This document is a response to the Jamaso (DA-2243-00) Second Technical Submission (5th Overall Review) comments received on June 6th, 2023 by the Office of Development Assistance. Responses are below in **RED**:

Jamaso Subdivision Filing No. 1
 City of Aurora, Colorado
 Master Drainage
 Historic Drainage Plan

Jamaso Subdivision Filing No. 1
City of Aurora, Colorado
Master Drainage
Master Drainage Plan

Proj Name: Jamaso
Location: Aurora, Colorado
Plan Set: PIP
Sheet Name: Public Improvement Plan

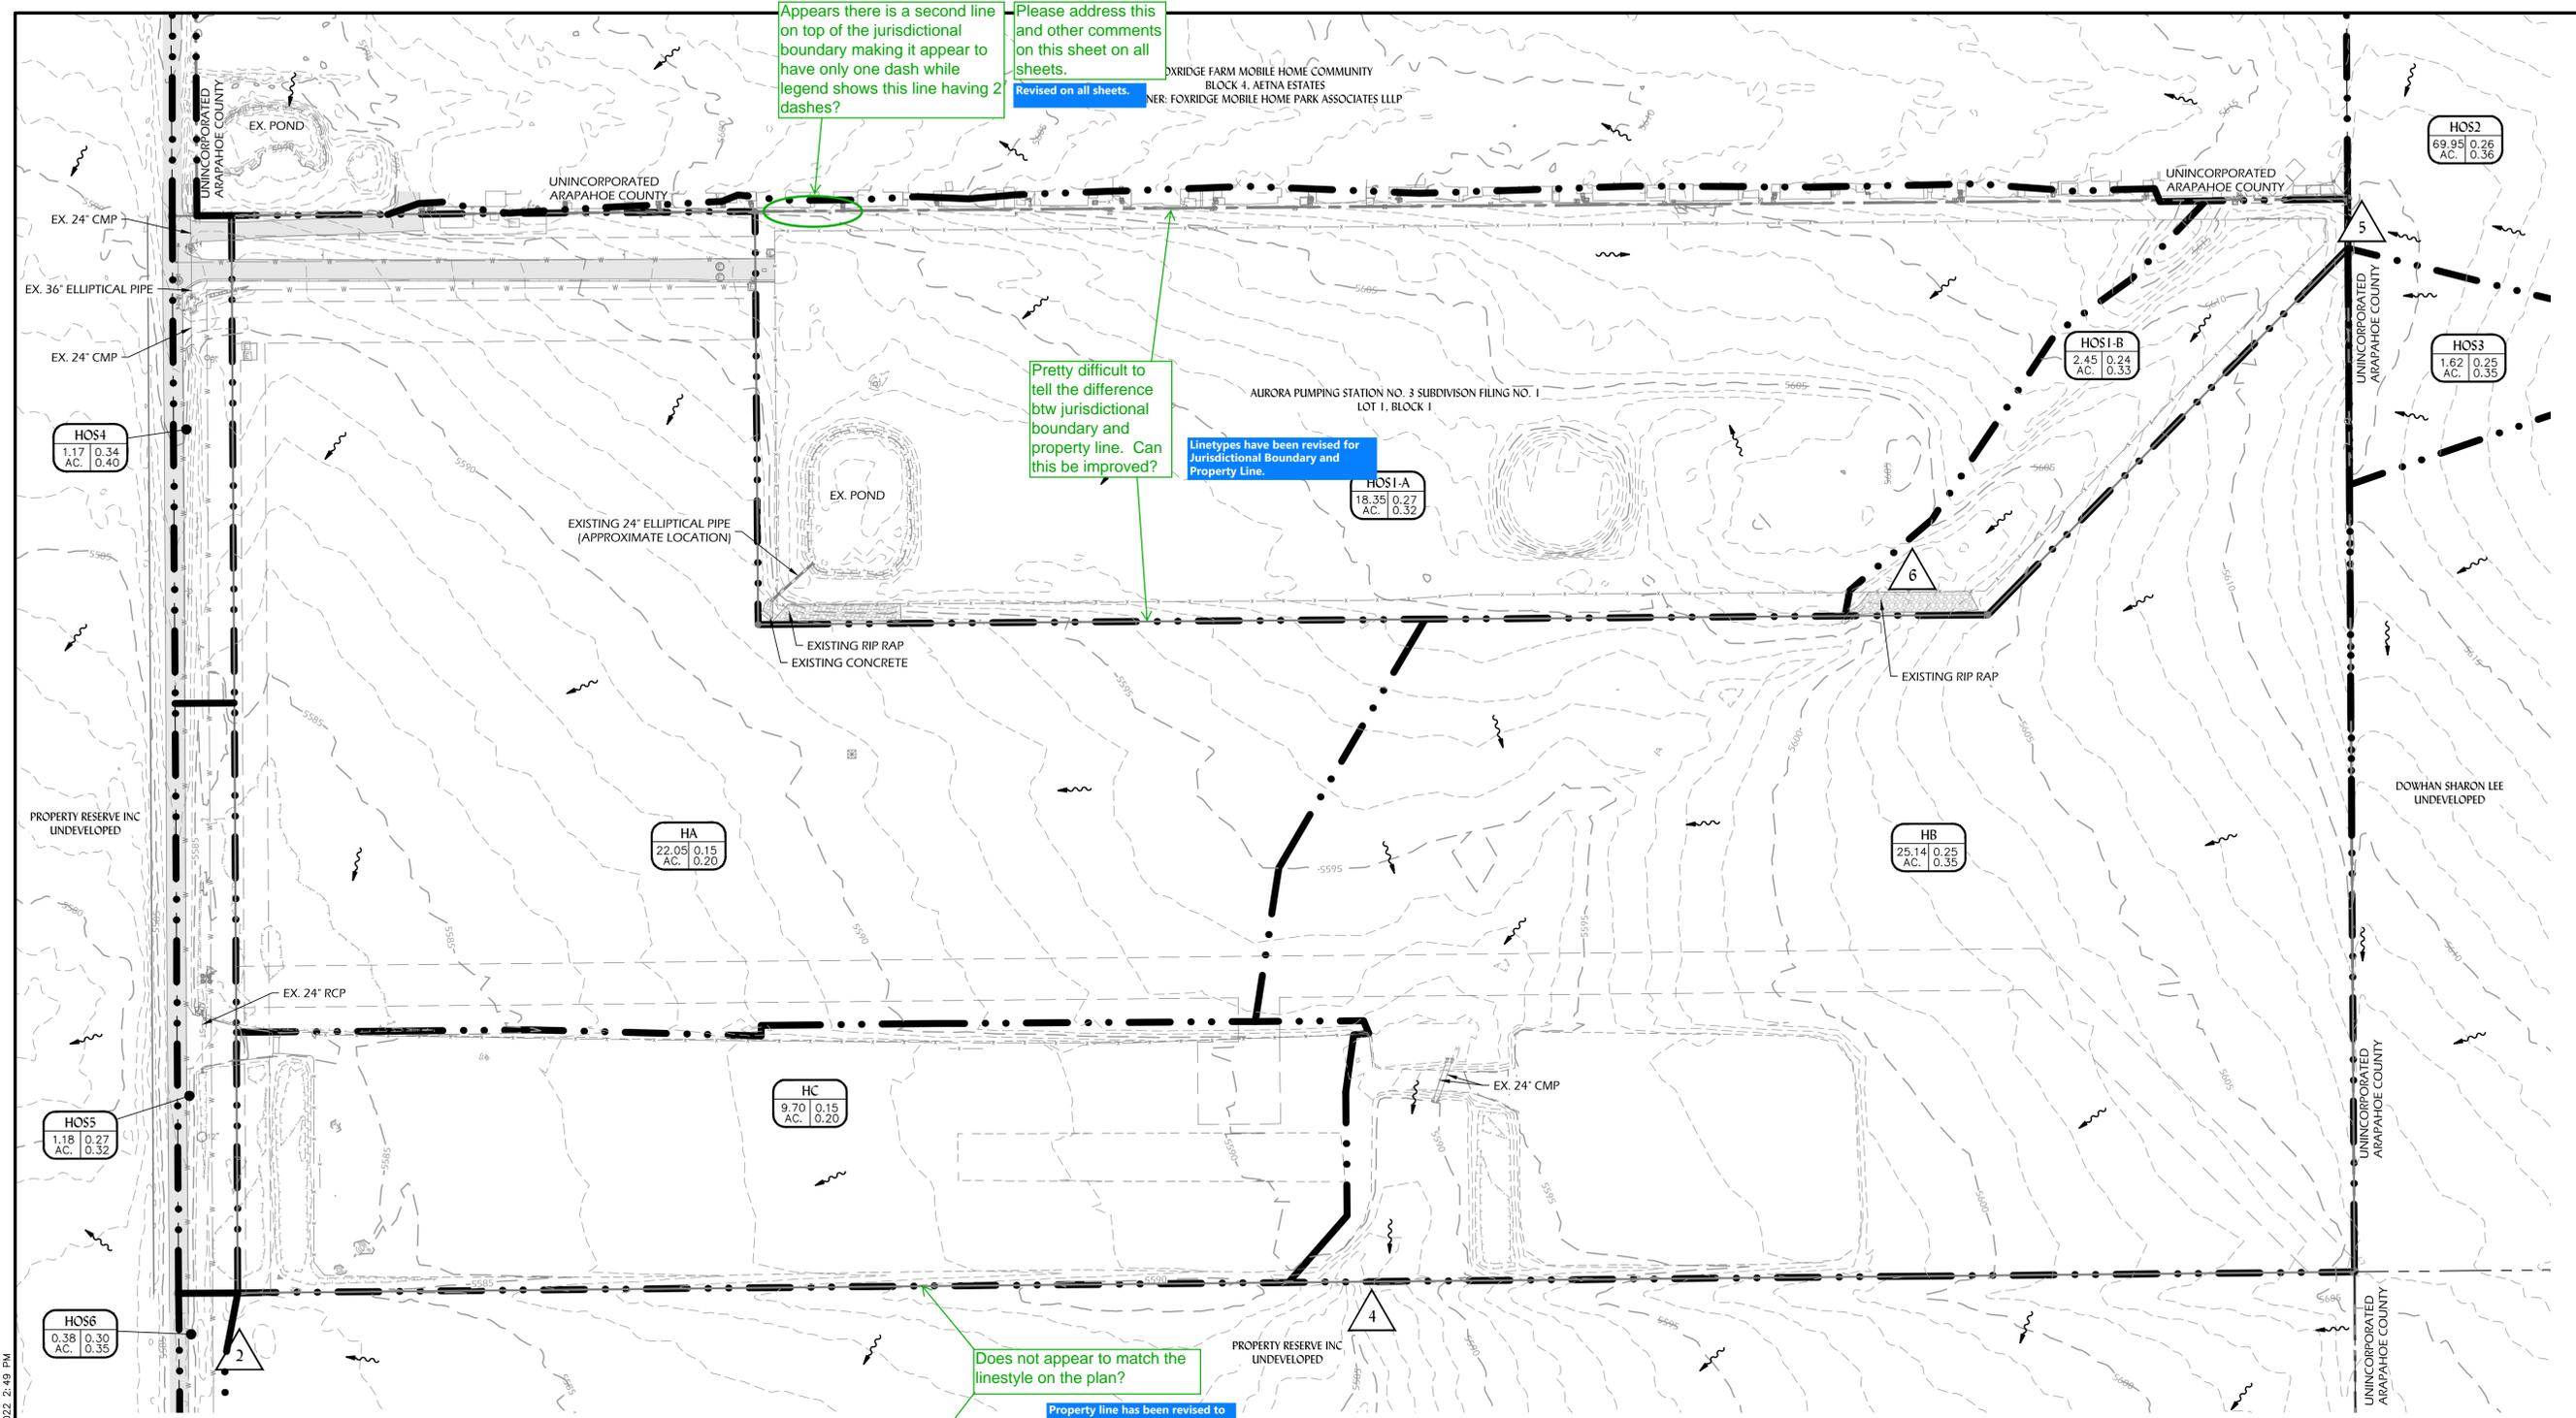
Appears there is a second line on top of the jurisdictional boundary making it appear to have only one dash while legend shows this line having 2 dashes?

Pretty difficult to tell the difference btw jurisdictional boundary and property line. Can this be improved?

Does not appear to match the linestyle on the plan?

Please address this and other comments on this sheet on all sheets. Revised on all sheets.

Linetypes have been revised for Jurisdictional Boundary and Property Line.

Property line has been revised to match Legend.

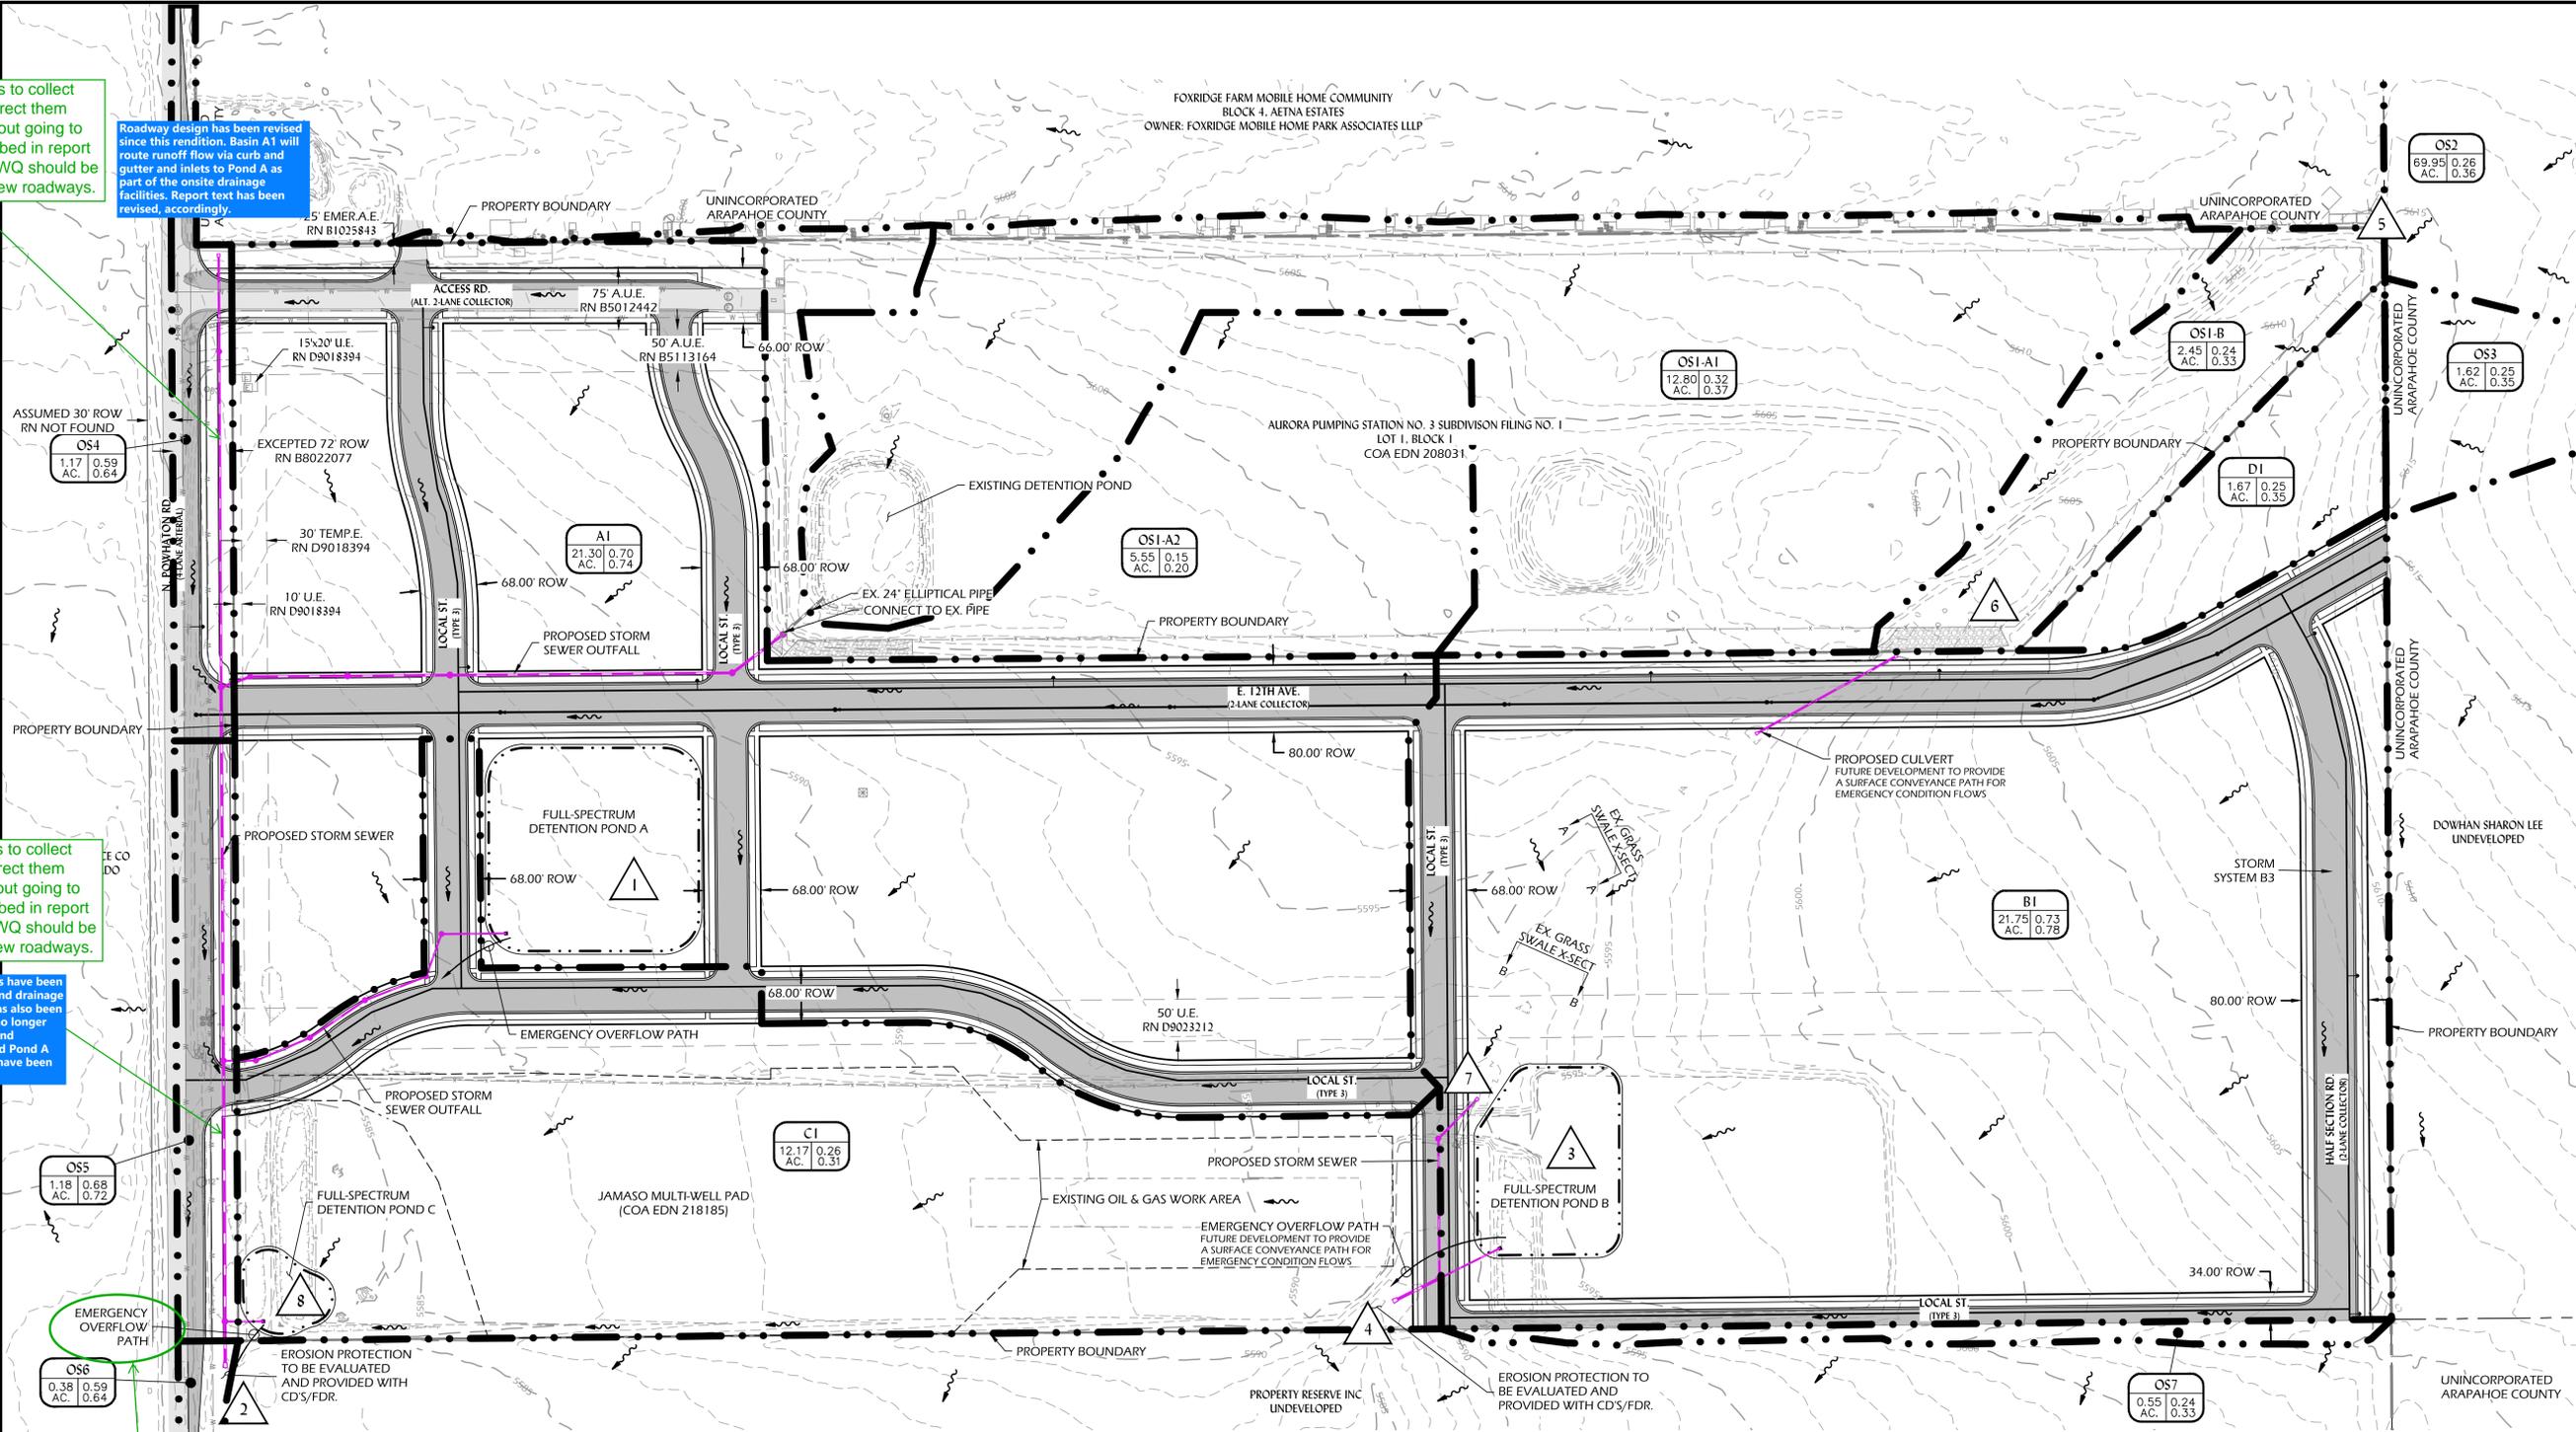
This pipe appears to collect OS4 flows and direct them south offsite without going to Pond A as described in report text. Det/EURV/WQ should be provided for all new roadways.

This pipe appears to collect OS5 flows and direct them south offsite without going to Pond C as described in report text. Det/EURV/WQ should be provided for all new roadways.

Please clarify the emergency overflow arrow (partly hidden under basin boundary). Important because emergency overflows here will go to private prop and at time of PDR will require written acceptance from owner to the south. See note requested to the right on this sheet.

Basin OS7 missing from table.
Basin OS7 has been added to the table.

Please show legend.

Add general note that where emergency overflows are directed to adjacent private property, written acceptance of emergency overflows from the adjacent owner will be required for approval of PDR.

Appears this would apply to Ponds B and C.

Roadway design has been revised since this rendition. Basin A1 will route runoff flow via curb and gutter and inlets to Pond A as part of the onsite drainage facilities. Report text has been revised, accordingly.

Several proposed roads have been omitted from design and drainage review. Pond design has also been revised since Pond C no longer exists and the design and discussion for proposed Pond A and proposed Pond B have been revised, accordingly.

Emergency overflow arrow has been revised for better clarity.

Legend has been added.

General note regarding emergency overflows has been added to general notes.

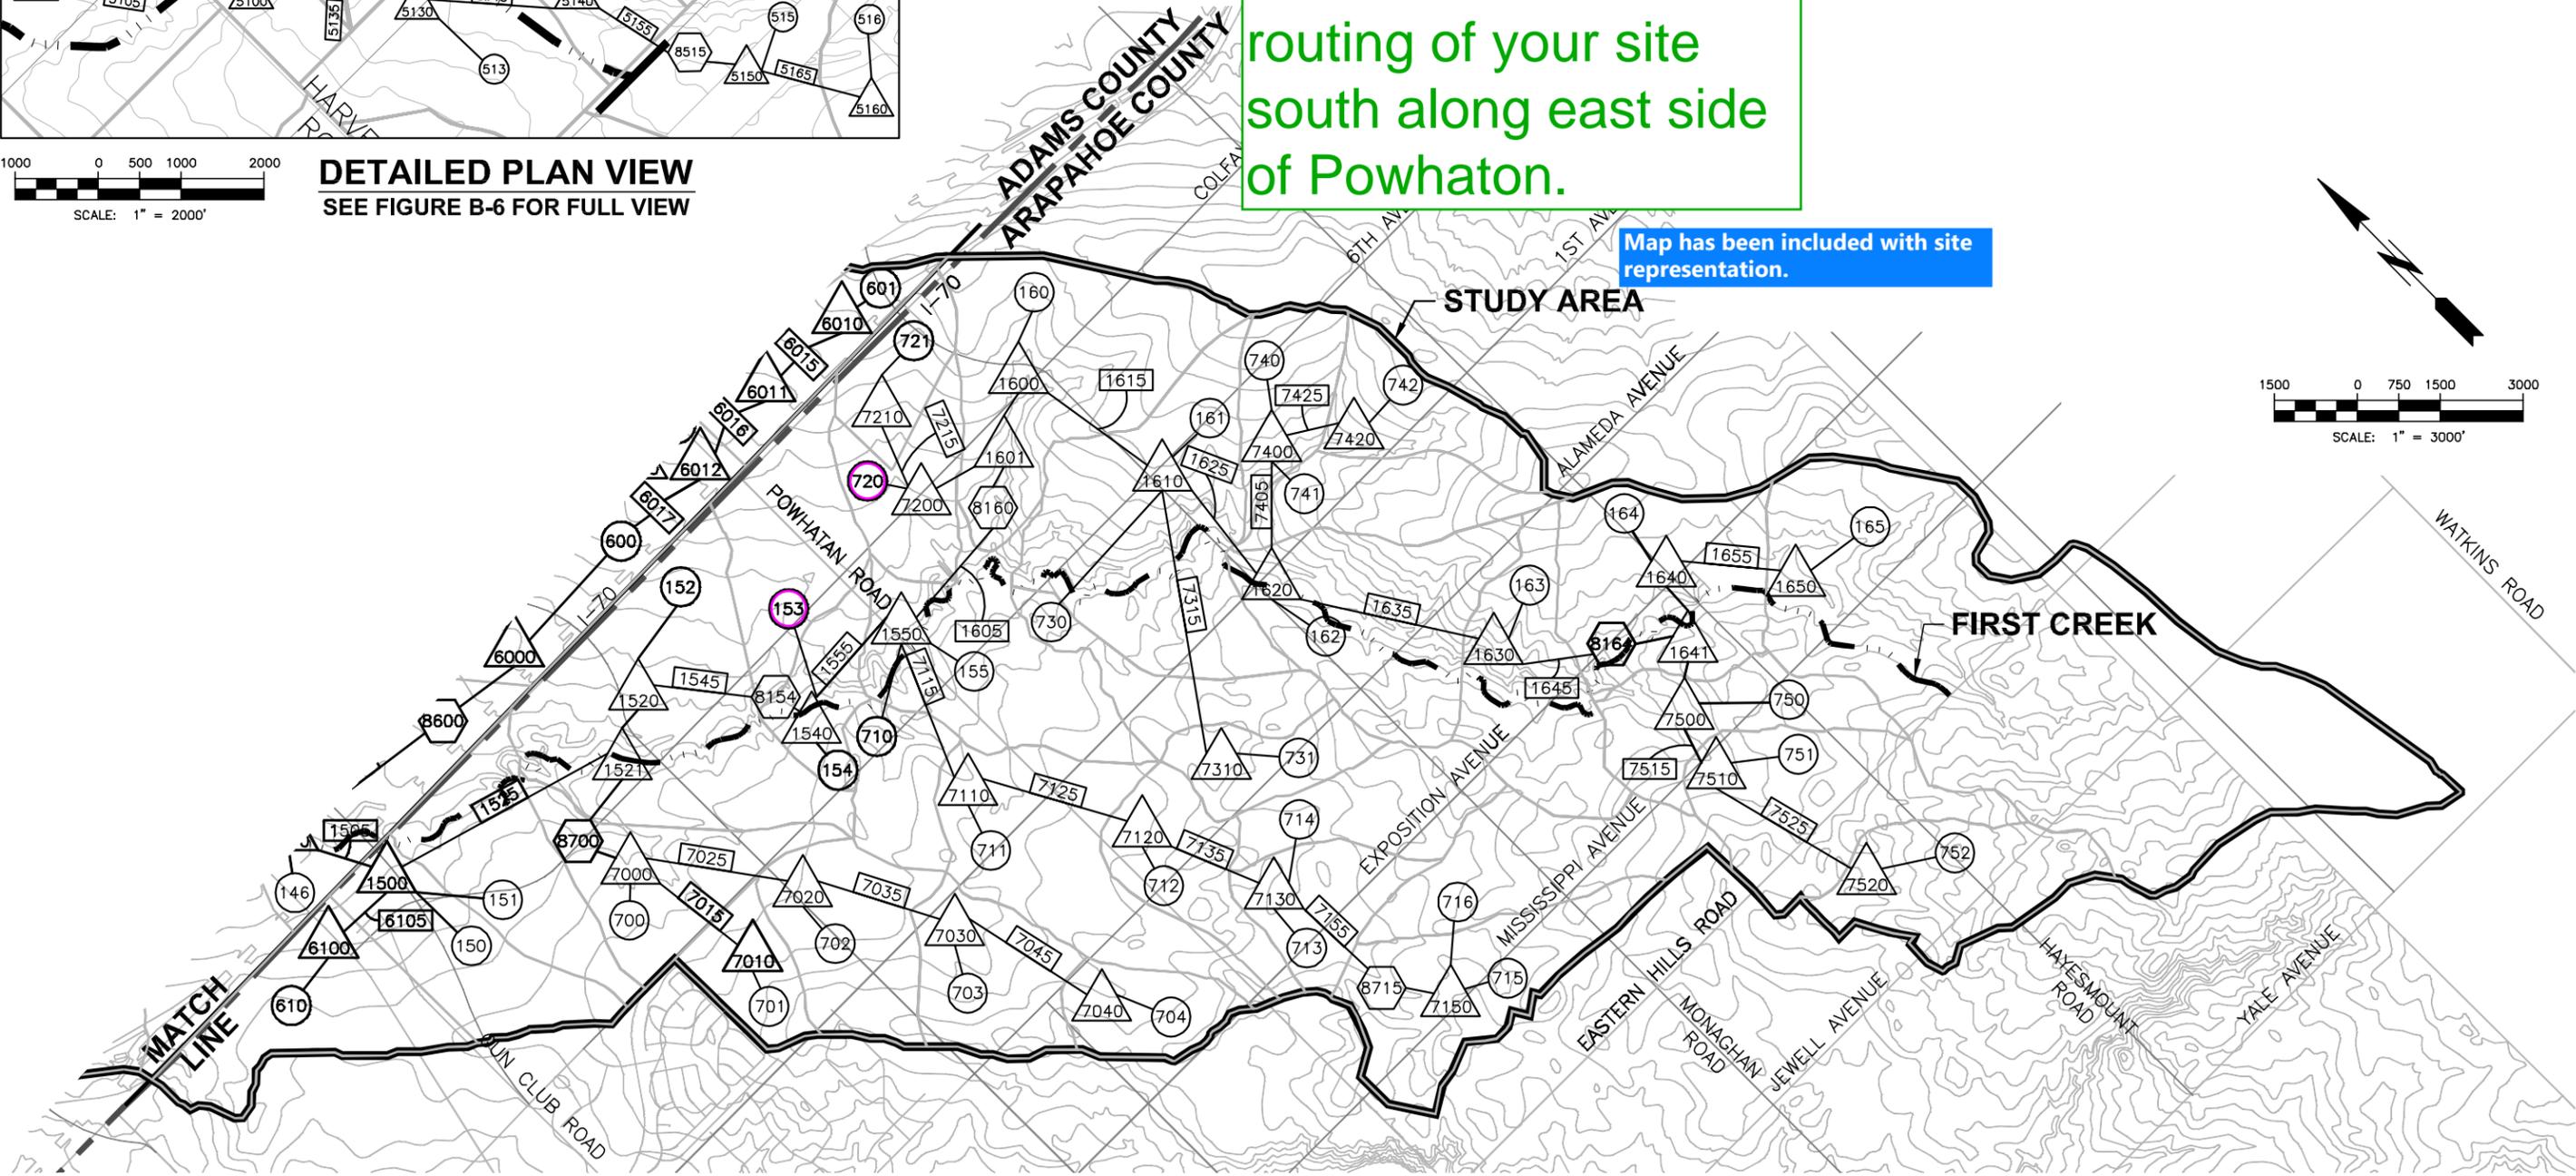
Please include a hydrology map from the 2019 First Creek Tribs MDP by Merrick. The map included should show the routing of your site south along east side of Powhatan.

Map has been included with site representation.
